**Technical Service Bulletin**

**Subject:** TSB – CP50 & CP50 Plus V01.00.01 SOFTWARE RELEASE

**Product(s) Referenced:** CP50 and CP50 Plus Electrocardiographs

**Summary:** The Welch Allyn Diagnostic Cardiology Team is pleased to announce a new version of software for the CP50 and CP50 Plus electrocardiographs. This version 01.00.01 software is a general maintenance release that incorporates several improvements outlined below.

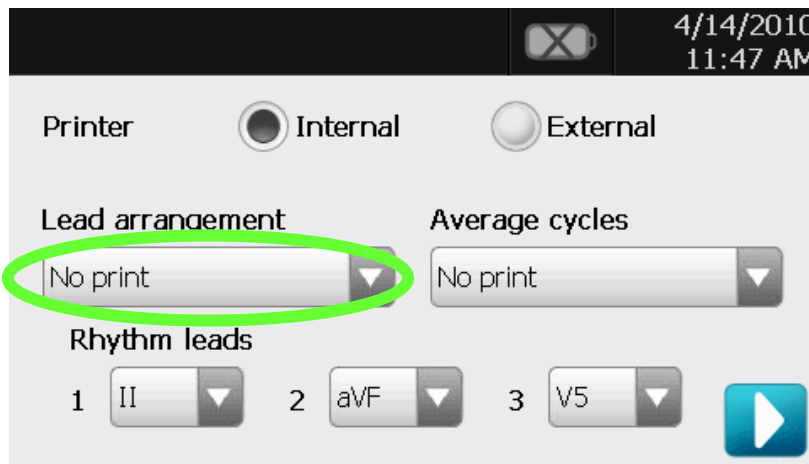
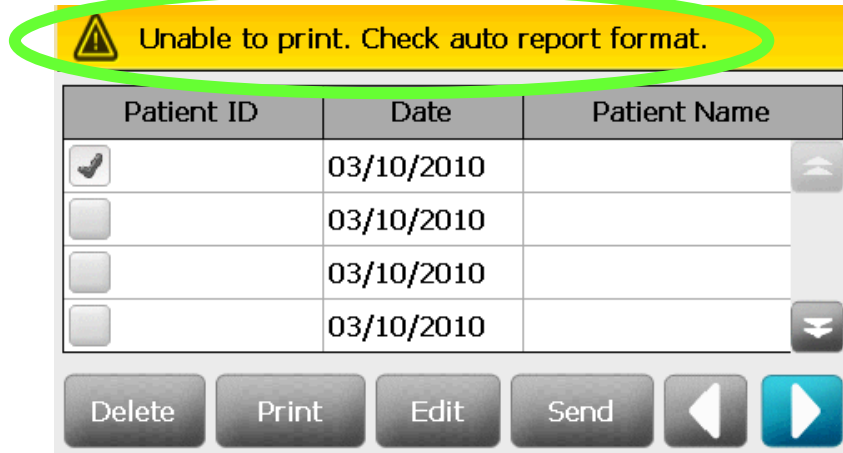
- **“No Print” option added to Auto report 1 and 2 lead arrangement configuration. *Menu>Settings>Auto Report 1 (2)*.**  
When enabled, Auto ECG will proceed from Patient Demographic to Acquisition to Analysis and straight to Post Auto ECG without printing. For STAT Auto ECG, the device will proceed from Acquisition to Analysis and straight to Post Auto ECG without printing if the Auto Report’s Lead configuration is set to “No print”.

When printing ECG test records from the ECG Test folder, if the selected Auto Report Format's lead configuration is set to "No Print", the device will display "Unable to print. Check auto report format" at the top of the screen.

*Menu>Settings>Auto Report 1 (2).*

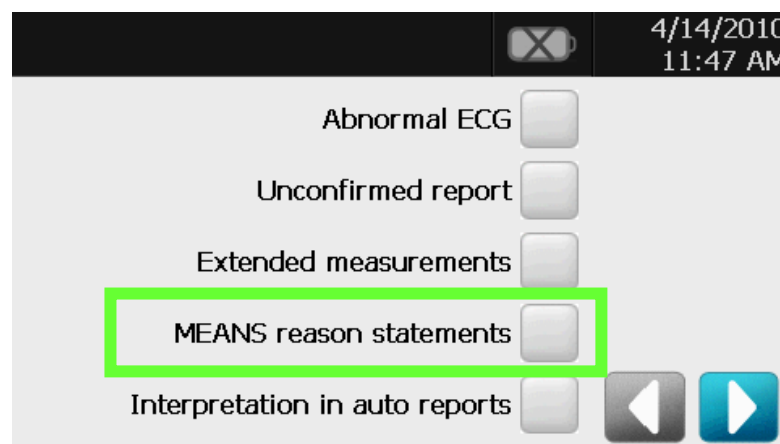
➤ **Option added for turning on/off MEANS reason statements on printout.** This option will be disabled (will not print) by default.

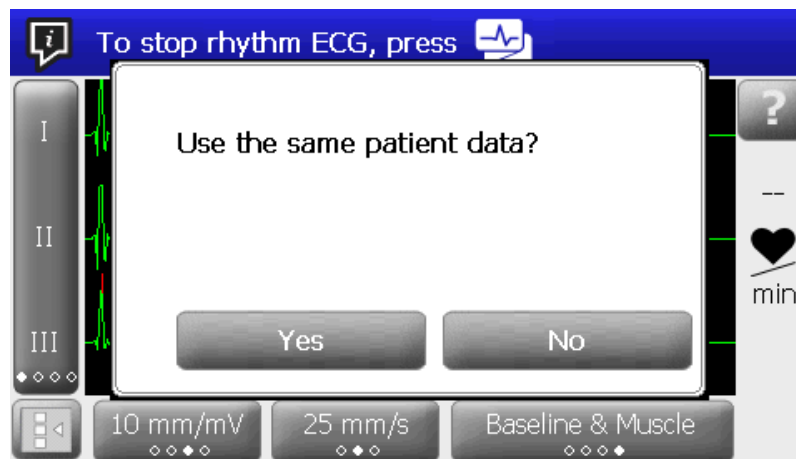
➤ **Corrected issue: Touch Screen calibration values were not used while device is in Maintenance Mode.**

The CP50 Touch Screen is calibrated during production however these values did not carry over when entering Maintenance Mode. The values will now be collected from memory.
